Slight minor adjustment on the proposed planning layout plan

A To meet 21 Metre Kirklees Concerning Plot 40 etc:- *Housebuilders Design Guide SPD 4.11*

Submitted Plan. Major Non-compliant to Kirklees Policy

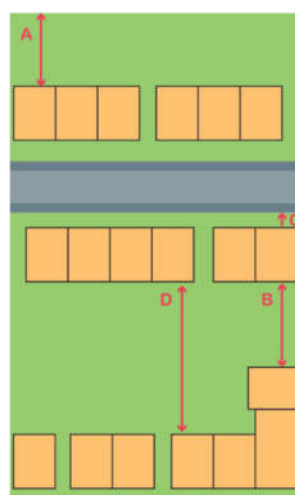
B To reduce overlooking of 10, 12 & 14 Broomhouse Close

Plots 36, 37/38 39 & 40 should be rotated clockwise

Plot 36 would rotate to be side-square on to the garages of plot 34, 35 and facing open woodland

Plot 37/38 would rotate to not be direct looking at the pumping station

Plot 39 & 40 would rotate and face open woodland

These adjustments should then comply with the National and Kirklees Policy LP24 Design;

and the Kirklees Housebuilders Design Guide SPD 4.11
